'CLASSIC' WITH DF-203 INSTALLED

TRANSFORMER WIRING DIAGRAM ASSIC

PEAVEY ELECTRONICS CORP. MERIDIAN, MS. DRAWN BY 757 DATE 2/28/83

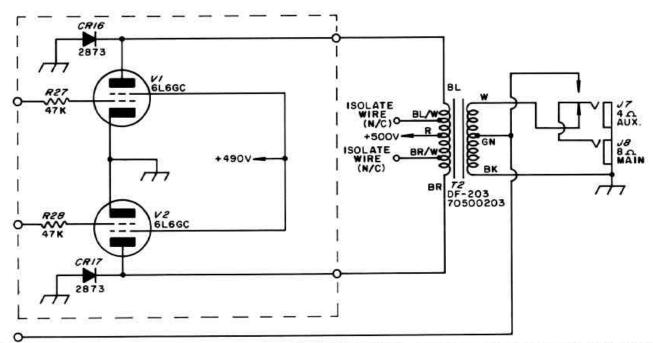
NOTES: I. THE BLUE/WHITE WIRE AND THE BROWN/WHITE WIRE COMING OUT OF THE DF-203 MUST BE ISOLATED SO THAT THEY MAKE NO CONNECTION.

2. THE BROWN AND THE BLUE WIRES COMING OUT OF THE DF-203 ARE CONNECTED IN REVERSE POSITION FROM THE ORIGINAL DF-184 TRANSFORMER.

3. SOME EARLY MODEL 'CLASSIC' AMPS DID NOT HAVE A WHITE WIRE COMING FROM THE DF-184 TRANSFORMER. IN SUCH CASES, ISOLATE THE WHITE WIRE OF THE DF-203 SO THAT IT MAKES NO CONNECTION. (SEE INSET)

4. IN MOST CASES, THE CHASSIS MUST BE RE-DRILLED FOR MOUNTING THE DF-203 DUE TO DIFFERENT MOUNT PATTERN.
